WASHINGTON STATE
DEPARTMENT OF TRANSPORTATION
CHANGE ORDER

CONTRACT NO: 009847 FEDERAL AID NO: ARPA001
 CONTRACT TITLE: US 101 & SR 116, NORTH OLYMPIC PENINSULA REMOVE FI
 CHANGE ORDER NO: 2 PRACTICAL DESIGN WORKSHOP-DBIC

CHANGE ORDER NO: 2

This Change Order revises the Contract by implementing Practical Design Solutions that were developed during the Practical Design Workshop. The Practical Design Workshop elements to be included by the Change Order are the following: 1. Elimination of lane reductions for US101 at Lees and Ennis creek, 2. Alternative longer span bridge design at US 101 Tumwater creek.

NOT FOR CONSTRUCTION	
US 101 / SR 116 NORTH OLYMPIC PENINSULA REMOVE FISH BARRIERS	
ENNIS CREEK MOT PHASE 1 SIGNING & PAVEMENT MARKING PLAN

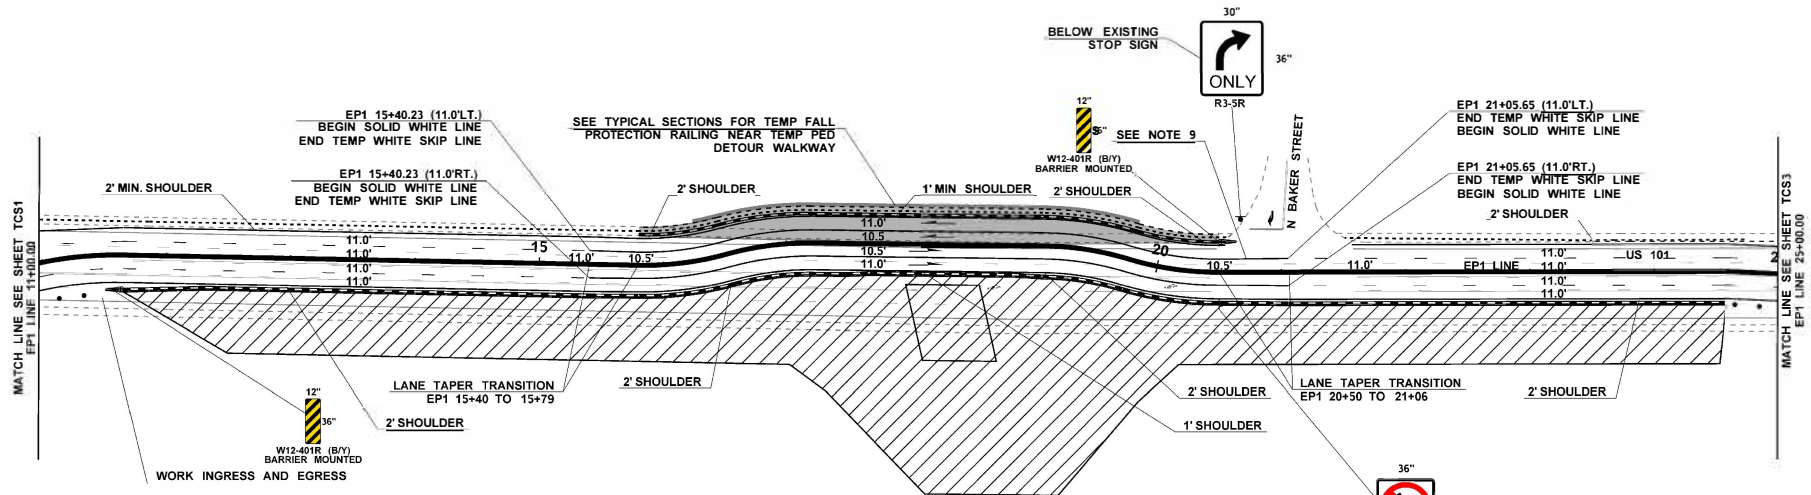
Section 2.22.4.2.1, page 2.22-12, after line 6, insert the following:
During phase 1 temporary alignment and construction staging at US101 Lees Creek and US101 Ennis creek as shown on page 4 and page 5 of this change order, the design vehicle SU-40 may be used for the inside lane.

Section 2.22.4.4.1, page 2.22-17, after line 15, insert the following:
Outside lanes during phase 1 of temporary alignment and construction staging at US101 Lees Creek and US101 Ennis creek as shown on page 4 and page 5 of this change order, shall be 11' and inside lanes may be reduced to 10.5' with signage requiring trucks to use the outside lanes.
